# Joint IEEE P802.3ct / P802.3cw Task Force Interim Teleconference

## Terminology Consistency

# IEEE P802.3ct D3.1 Terminology Review

Figure 154-3—Black link example configuration for specifying  $n$  DWDM channels

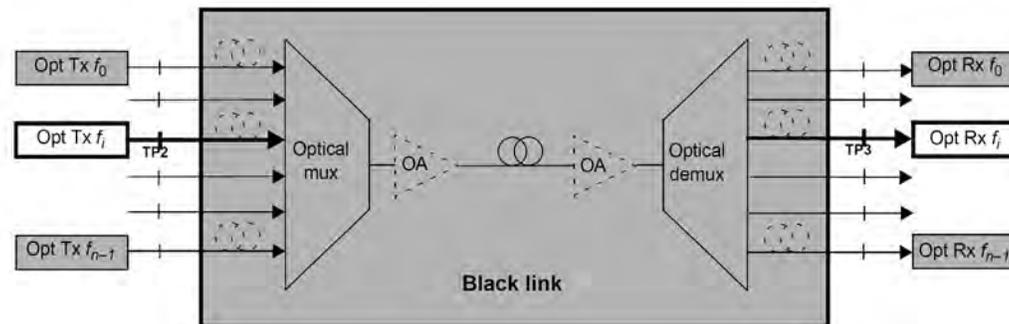
1. There should be consistent use of terminology between IEEE P802.3ct and ITU-T G698.1 / .2.
  1. IEEE P802.3ct should not create new definitions for terms used in referenced ITU-T documents.
  2. IEEE P802.3ct should create a new term, before assigning a new definition to an ITU-T used term.
  3. Terminology should be consistent with IEEE 802.3 usage.
2. The term “Black Link” should not be used to define **both**:
  1. The specification methodology
  2. The “grey box” (everything between TP2 and TP3 for the aggregate of DWDM channels) as implemented
3. A different term is required for the “grey box” (see Figure 154-3 below).

- Change “Black Link” to “Black Link Approach” and the associated definition:
    - Black Link Approach - the specification of the input, output, and transfer characteristics of the unidirectional transmission path between TP2 to TP3 for a given DWDM channel within a DWDM Link, without specifying how the transmission path is implemented. (See, for example, IEEE Std 802.3, Clause 154, Figure 154–3)

# Review of ITU-T Recommendation G.698.2

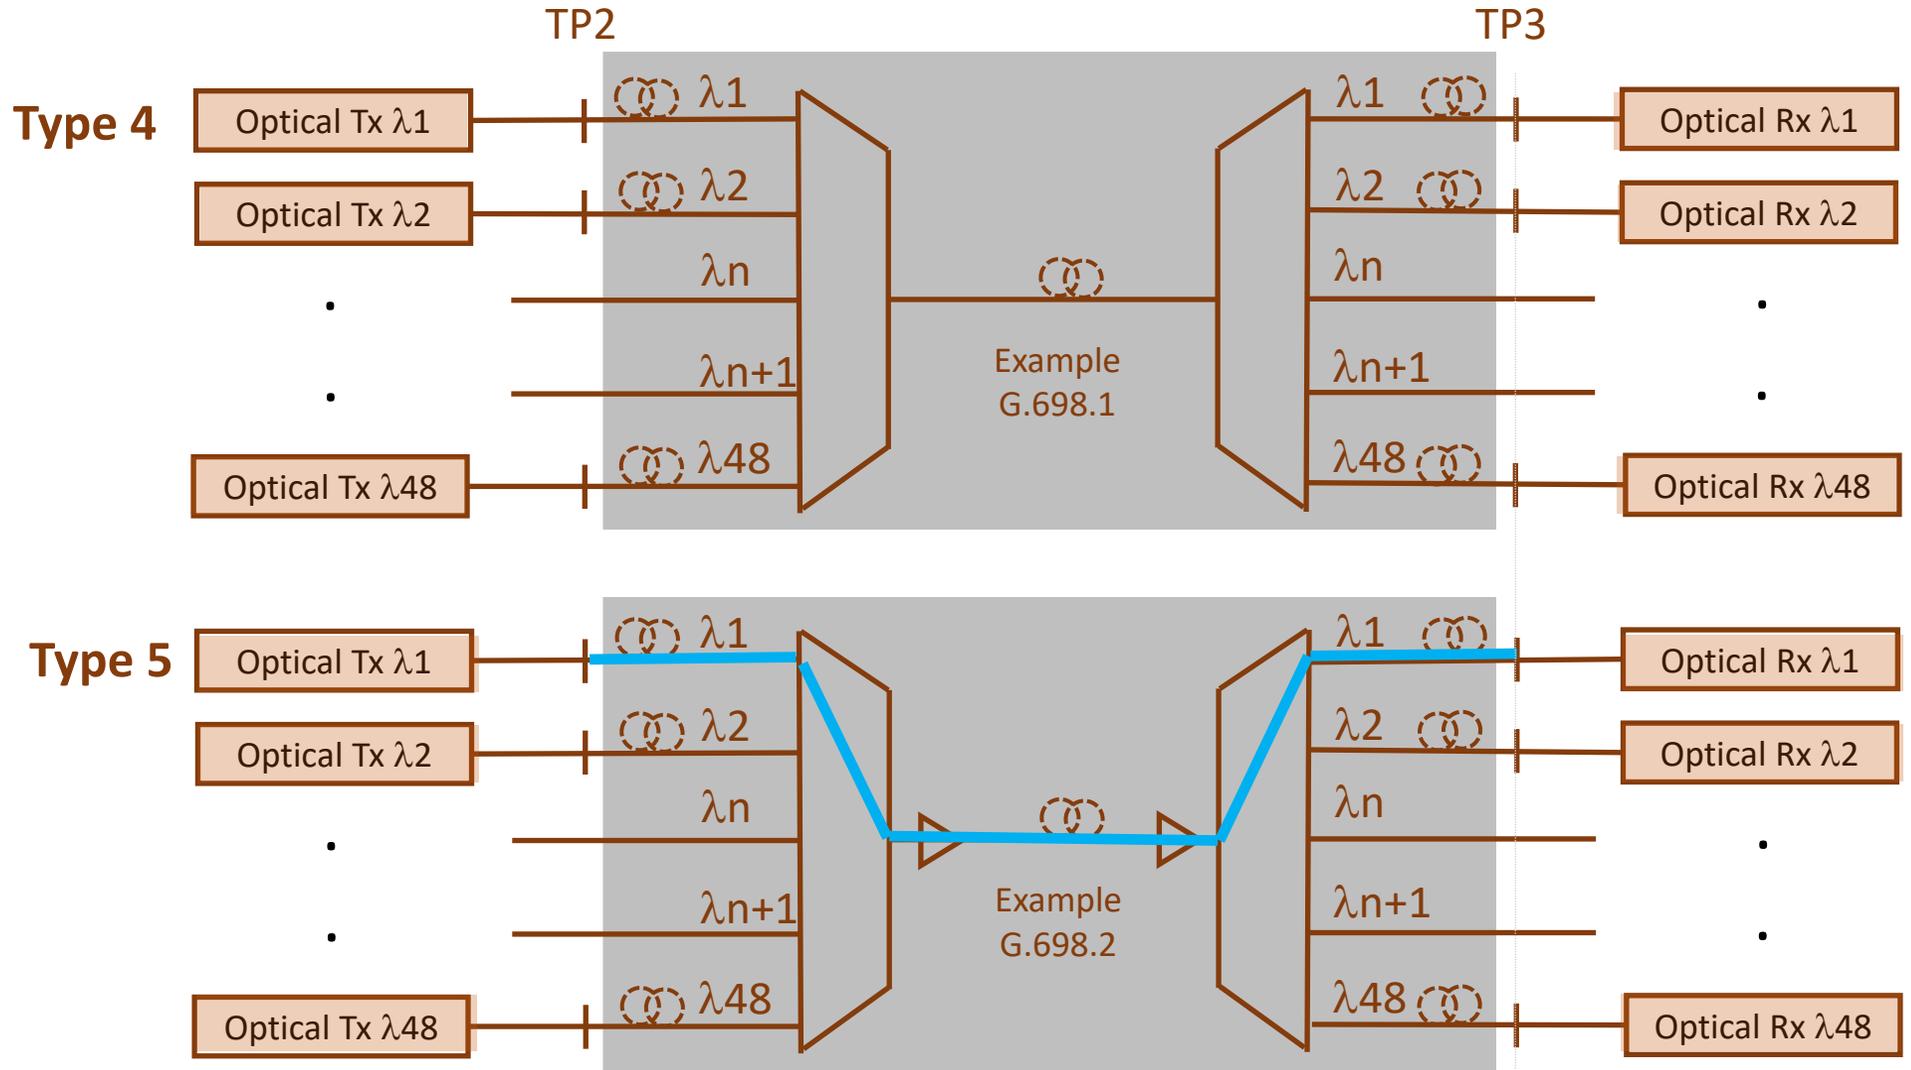
- The following terms are not defined in Clause 3 (Terms and definitions)
  - DWDM Link
  - Black Link
  - DWDM system
- “DWDM Link” appears 10 times
  - In the box between all Ss and Rs: Fig’s 5-1, 5-2, 5-3, 5-4, II.2
  - In Clause 5.3, Nomenclature, 7.2.1 Maximum and minimum mean channel output power, 7.4.4
- “Black Link” appears 52 times
  - Observation – appears to be used similarly as what is implemented in P802.3ct D3.1 –
    - The “approach” (P802.ct: “specification methodology”)
    - The “grey box” – everything between all Ss and Rs (P802.3ct: everything between TP2 and TP3 for the aggregate of DWDM channels)
  - Only instance of “Black Link” appearing in grey box diagram is Figure II.2 (also called DWDM Link)
- “DWDM System” appears 5 times
  - In “Summary” – not clear if the “grey box” or as defined in P802.3ct D3.1
